APPENDIX B

MAJOR COMMENTS AND DOE RESPONSES

A-1 The Department of Health, Education, and Welfare has reviewed the health aspects of the Draft Environmental Impact Statement, DOE/EIS-0023-D, Long-Term Management of Defense High-Level Radioactive Waste, Savannah River Plant, Aiken, South Carolina, and have the following comments to offer.

Figure 1: EPA has revised Figure III-3 (page III-5) from the source document to show the local mylonite zones and the fault between the Triassic sedimentary rock and the Metamorphic basement rock. The Tuscaloosa Aquifer is in the formation labeled as "Nonmarine Sediments of Late Cretaceous Age."

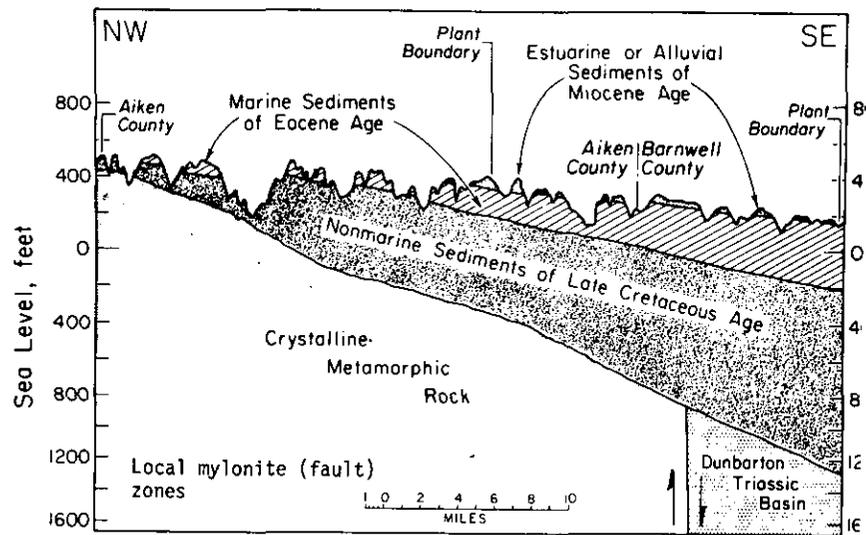
L-13 The basement rock beneath the Savannah River Plant is described in the draft EIS as crystalline metamorphic rock grading into Dunbarton Triassic Basin rock to the southeast. A vertical geologic cross section to a 2,000 foot depth is depicted in Figure 1 and shows approximately 1000 feet of unconsolidated sedimentary rocks overlying older crystalline metamorphic and Triassic sedimentary basement rock. The contact between the older crystalline metamorphic rock and younger sedimentary Triassic basement rock is a normal fault and predates the Triassic deposition. The presence of

L-14 The 500 foot thick Tuscaloosa aquifer overlying the basement rock is one of the most important aquifers in the southeastern United States (See Figure 1). A saprolite clay of an average of 70 feet in thickness separates the basement rock from the aquifer, but locally this clay is absent. The investigative report of the National Academy of Sciences (1972) assumes that water from the basement rock is being transmitted upward into the Tuscaloosa aquifer at a rate of 0.002 gpd/ft<sup>2</sup> where clay is present, but at 0.0035gpd/ft<sup>2</sup> wherever the clay may be absent. To date, no absolute hydraulic separation of the basement rock from the Tuscaloosa aquifer has been proven by the chemical evidence available and it may be presumed that movement of waters between the basement rock and the aquifer occurs in accord with existing permeabilities and hydraulic gradients. The possibility of aquifer and basement water mixing, involving potential high-level nuclear waste, presents a potential risk of contamination in the Tuscaloosa aquifer and the biosphere.

The gross separation of the waters of the coastal plain aquifers and those of the bedrock are shown by: (1) the abrupt discontinuity in their chemistries TDS  $\approx$  30 mg/l at the base of the coastal plain aquifer and 6000 mg/l in the crystalline metamorphic rock; (2) pumping about 1500 gpm in each of two plant areas continuously for 27 years has not caused a decline in hydraulic pressure in the crystalline rock; (3) a year-long pumping test in the crystalline rock showed no indication of leakage through the saprolite; (4) a large amount of helium has accumulated in the waters of the crystalline rock which could not have accumulated if there were even minor leakage from the metamorphic rock. Therefore, although it has not been conclusively demonstrated, the water mixing potential is considered to be extremely low. Migration of radionuclides from the cavern was considered in the preparation of the EIS and the potential environmental impact was determined to be insignificant.

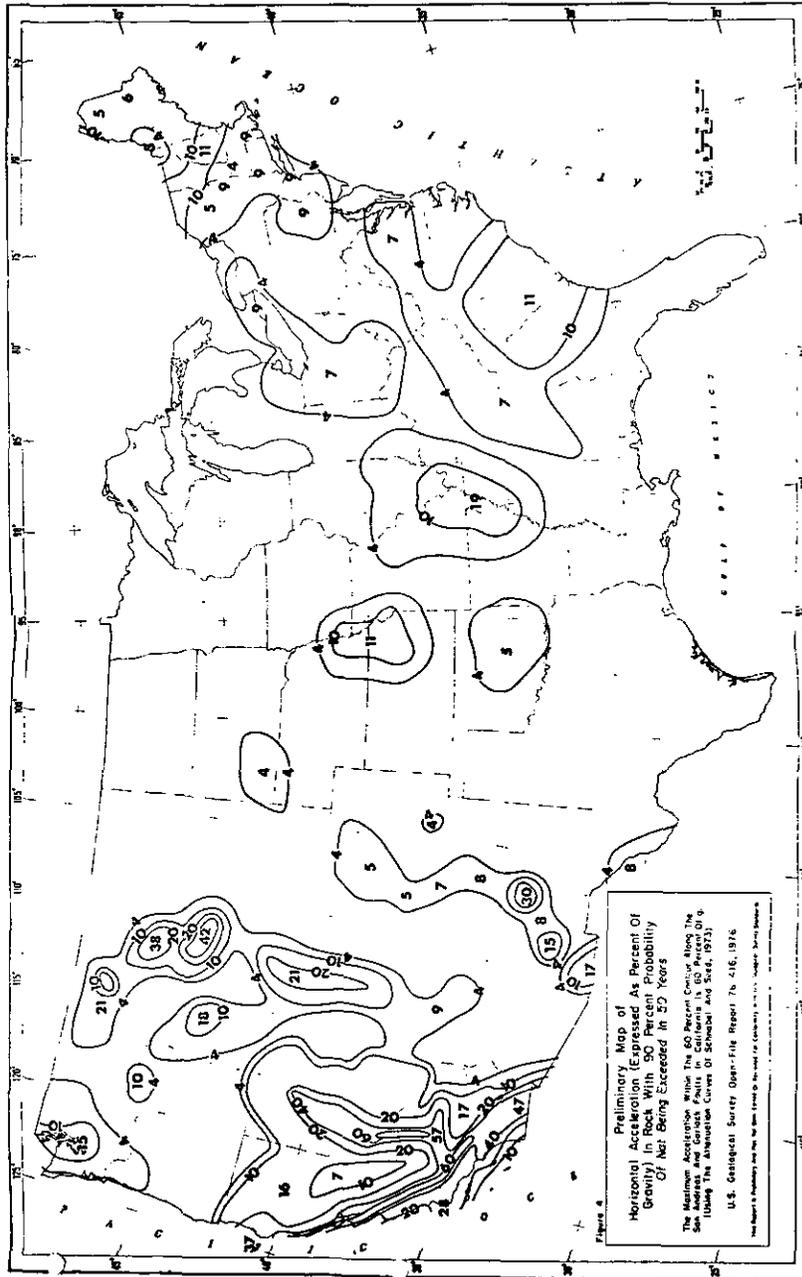
L-15 A map of earthquake hazard developed by Algermissen and Perkins, 1977, is depicted in Figure 2. Although the hazard in the East is lowered by the relative infrequency of large earthquakes, the total time in the last 250 years is actually greater than that in the West. As shown in Figure 2, the highest number in the East centers around Charleston, S.C., which in 1886 was the site of an earthquake of Intensity X on the Modified Mercalli Scale. While the cause of this severe earthquake is speculative as to origin, the earthquake epicenter lies but a few miles from the Savannah River Plant site.

The fact that the metamorphic bedrock is locally faulted and fractured makes bedrock disposal, even in the Triassic sedimentary rock, and unviable option at SRP. At a minimum, these geological problems should be discussed more adequately in the final EIS.

As stated on page III-11 of DOE-EIS-0023, the epicenter of the Charleston Earthquake of 1886 was about 90 miles from SRP. All investigations of known faults in the metamorphic bedrock have shown that they are noncapable faults. The options for storage of waste in bedrock assume that the cavern would be constructed in nonfaulted bedrock. Extensive field study would be required to determine whether disposal in a nonfaulted area is in fact feasible but studies to date do not preclude this possibility.
